MANDATORY SERVICE BULLETIN

No. 2053
ATA Code 28-20

SUBJECT: FUEL SYSTEM - ADDITION OF A DECAL AND A FUEL SELECTOR STOP TO THE FUEL SELECTOR VALVE GUARD

REASON: To minimize the possibility of inadvertently turning the fuel selector valve to the OFF detent position.

Figure 1

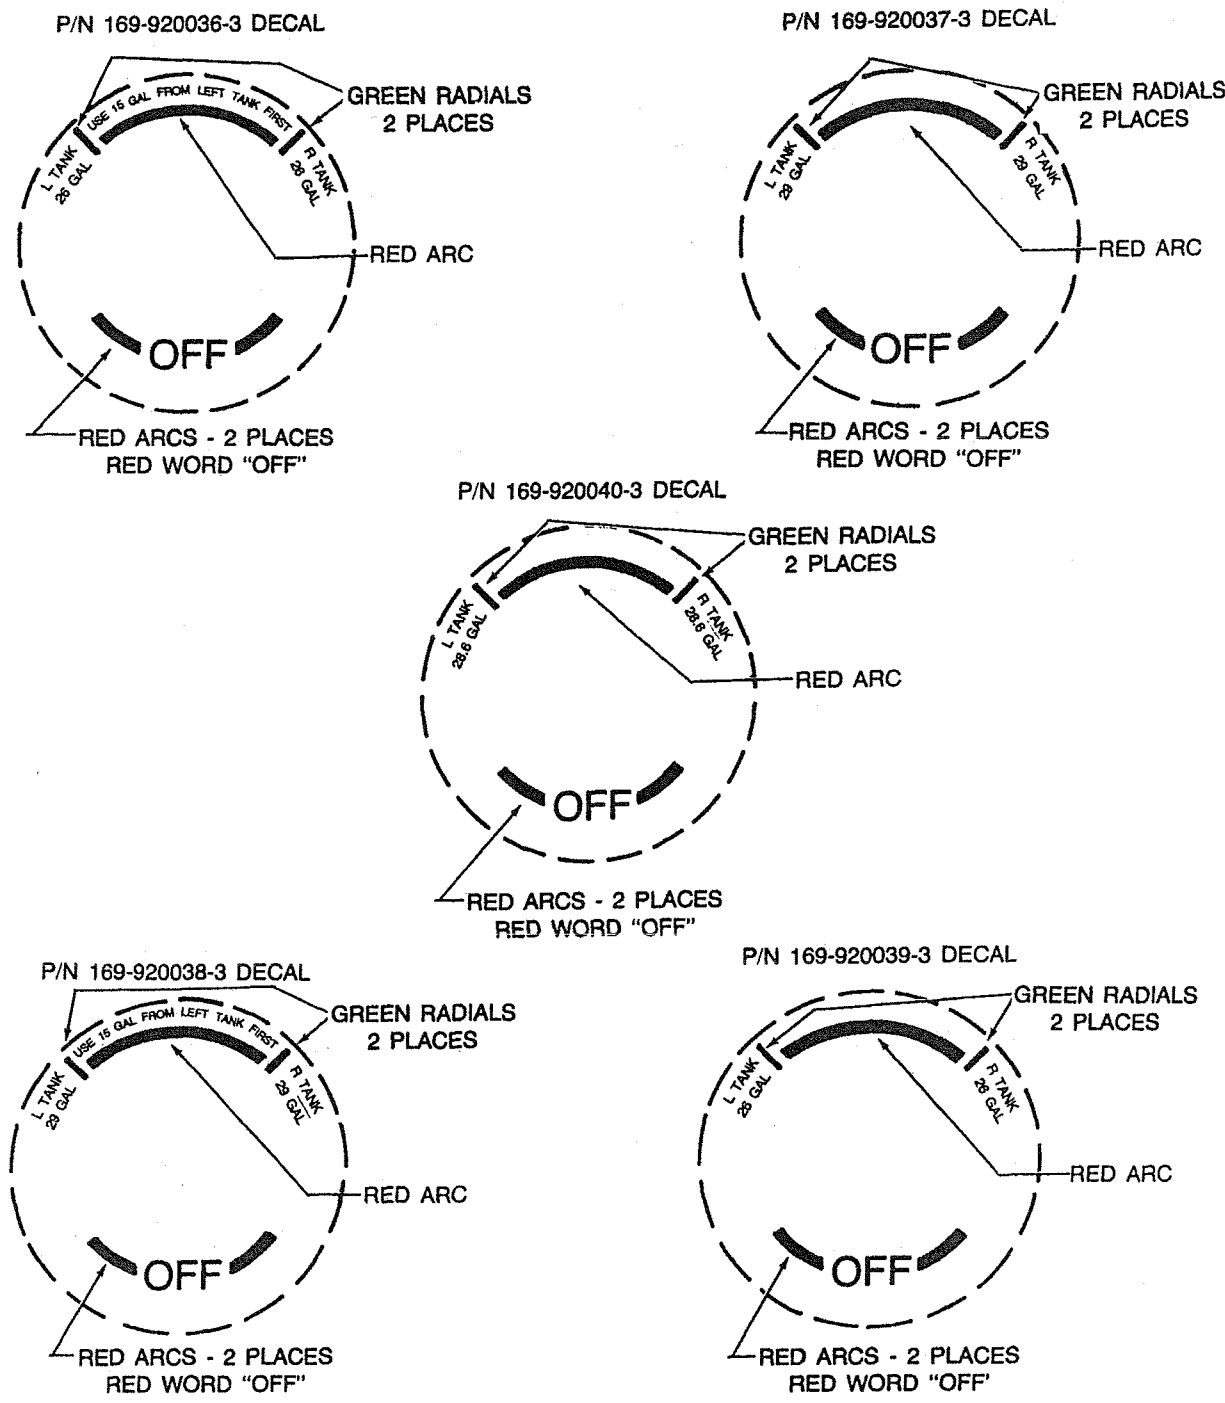
3. Install the appropriate pressure sensitive decal, as determined from Figure 1 and from the MATERIAL section, to the fuel selector valve guard.

2. Inspect the fuel selector valve guard for the correct placard. Placard instructions, if any, and usable fuel amounts should match one of the decals shown in Figure 1. Refer to MATERIAL section.

Figure 2

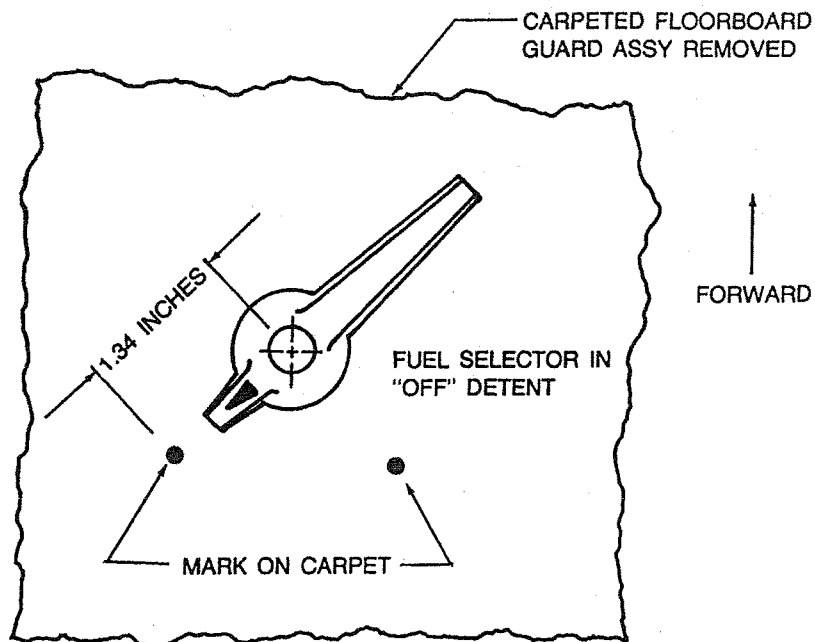
4. Replace the fuel selector valve handle and turn the handle to one of the "OFF" detents. Refer to Figure 2.

5. Using paint or chalk, place an "X" mark on the carpet directly in line with the fuel selector handle at a distance of 1.34 inches from the center of the screw that secures the fuel selector handle.

6. Move the handle to the other "OFF" detent and make a similar mark.

Figure 3

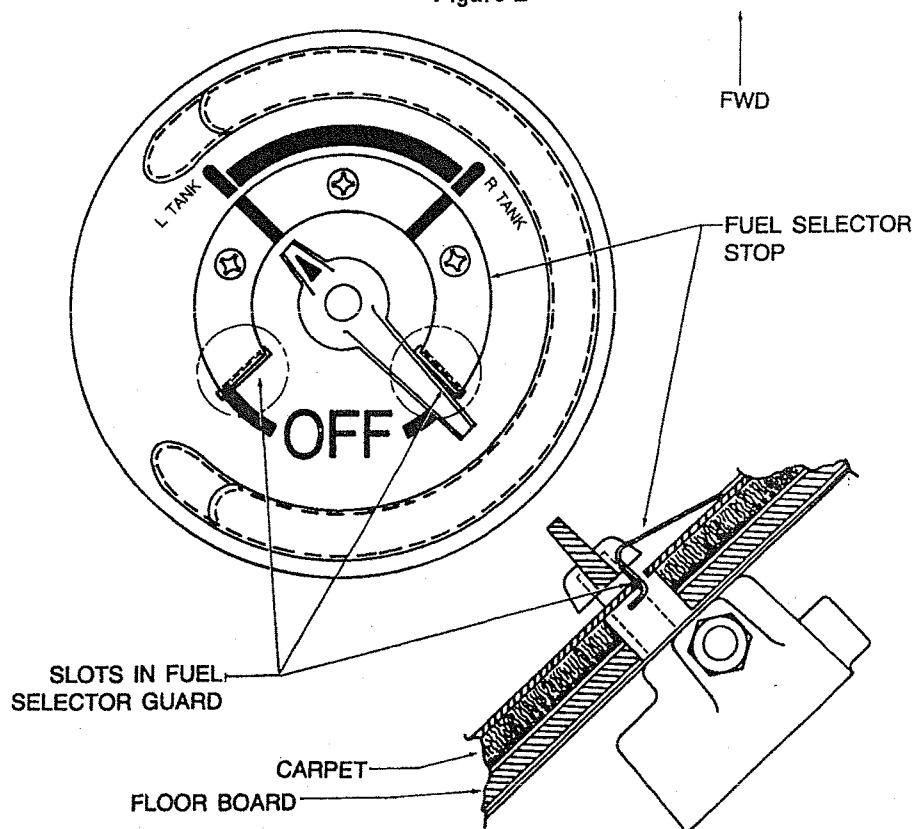
13. Mark and cut two slots .20 inch by .90 inch to clear the vertical legs of the selector stop, as shown in Figure 3.

15. Attach the fuel selector handle, and position the guard and the fuel selector stop so that the green radials on the guard and the fuel selector stop line up with each other and with the index on the fuel selector handle as shown in Figure 3. It may be necessary to trim the nap of the carpet under the flat surface of the guard in order to provide sufficient clearance between the guard and the fuel selector handle.
